Department of Transportation

The following attachments are submitted to the MUTCD NPA docket as part of NYCDOT's comments.

Attachments include:

Figure 3J-6 XY-8 Examples of Curb Extensions Designated by Pavement Markings

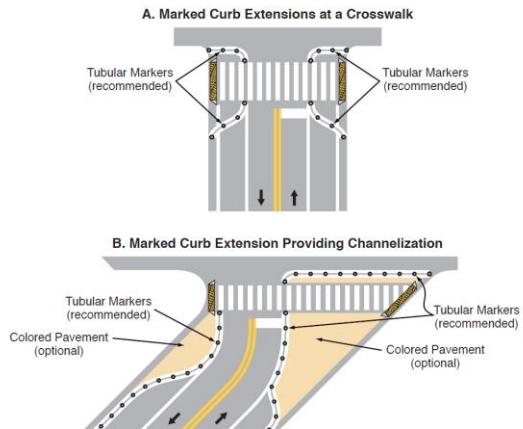
Figure [XY-9](#) ~~3J-6~~ illustrates examples of curb extensions designated by pavement markings.

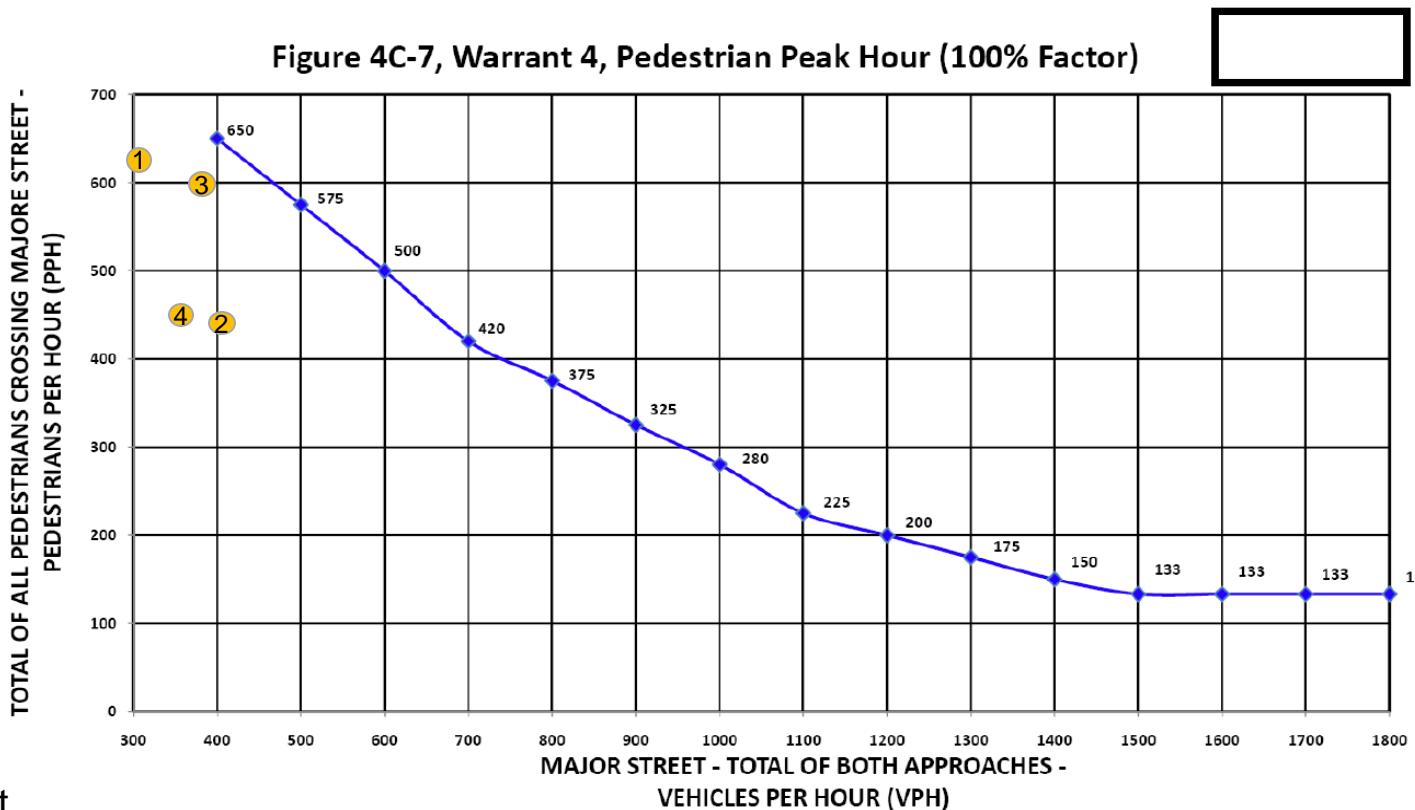
NYCDOT approved controls at the following locations using the modified warrant. The chart below shows where they fell on the 100% factor.

None met the warrant due to low vehicle volumes despite high pedestrian volumes.

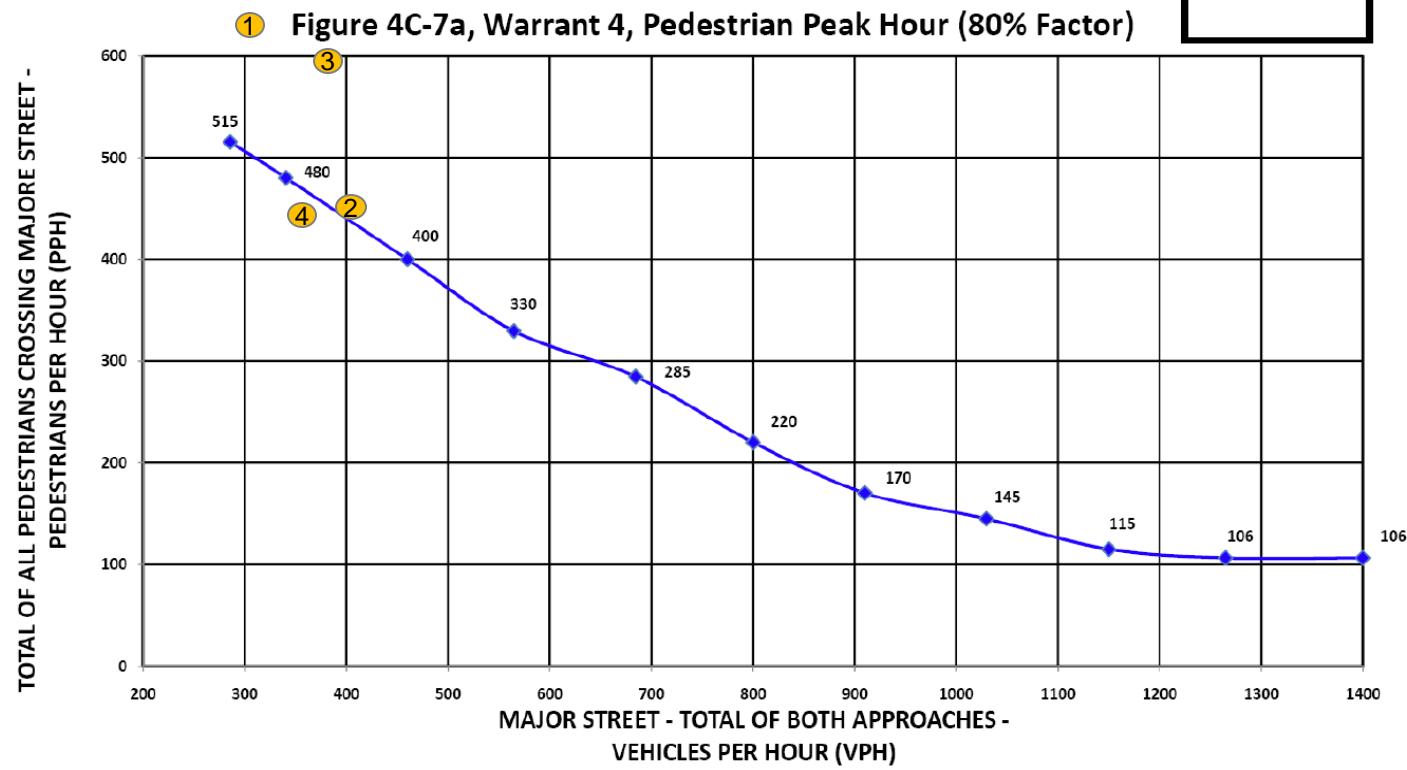
The 80% factor graph shall be used for intersections having 1-2 preventable crashes in a 12-month period.

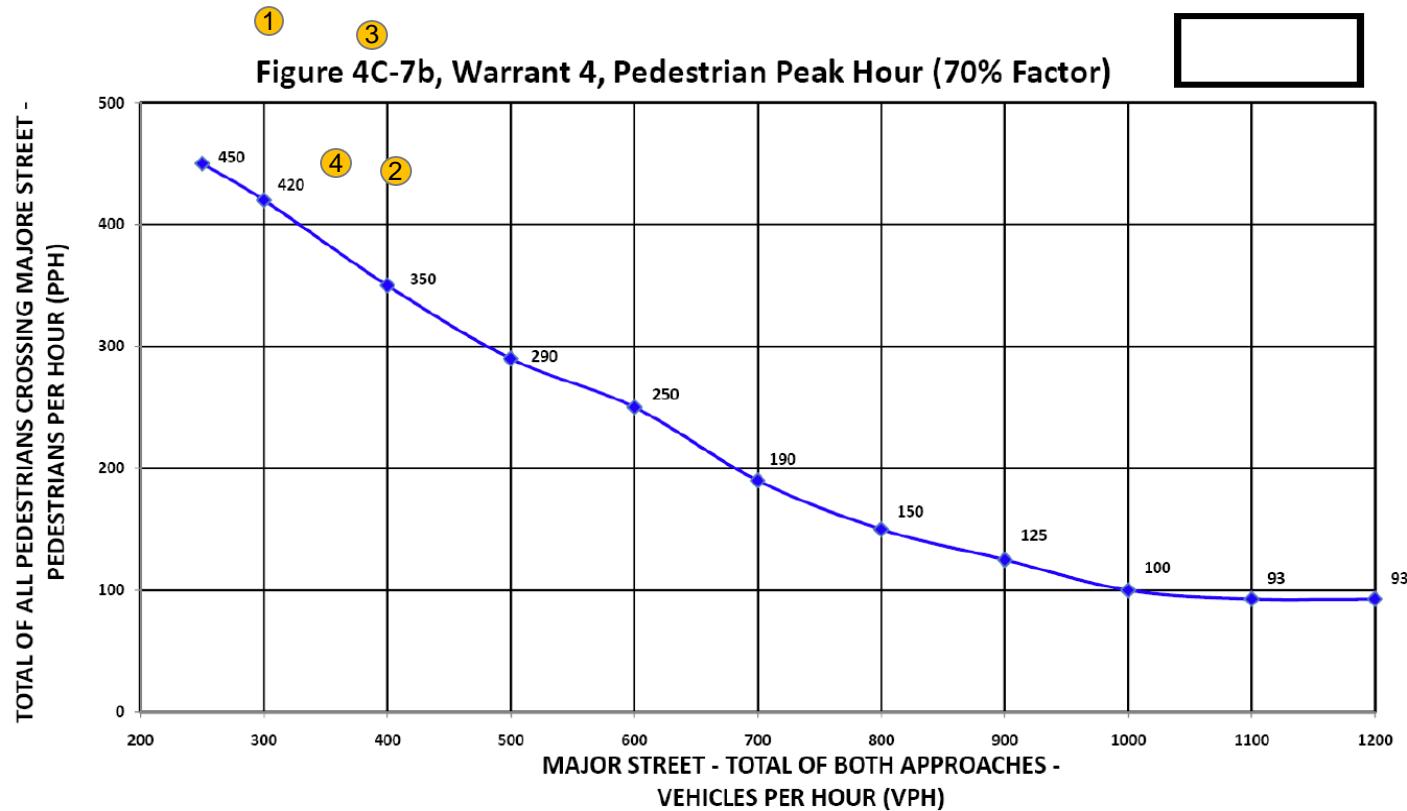
The 70% factor graph shall be used for intersections having 3-5 preventable crashes in a 12-month period or if the 85th percentile speed on the major street exceeds 35 mph.

Figure 4E-2. Pedestrian Intervals

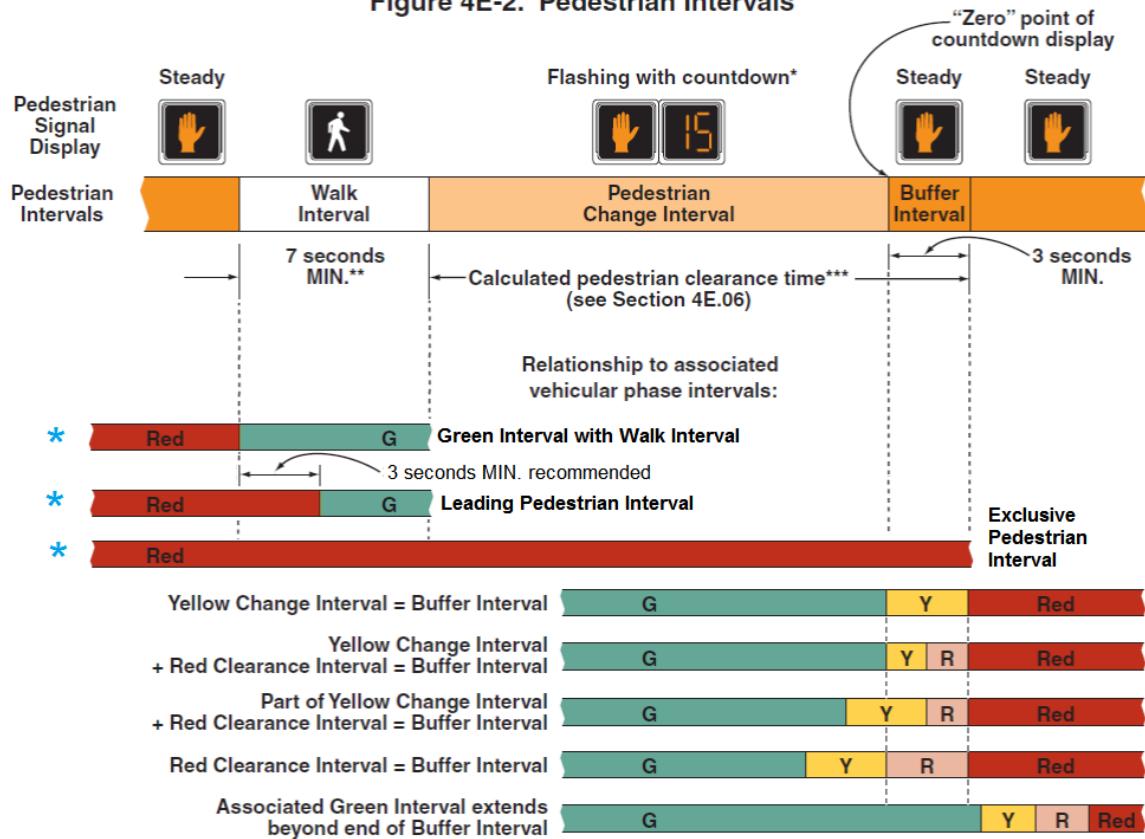
Proposed updated Pedestrian Interval Figure 4I-4:
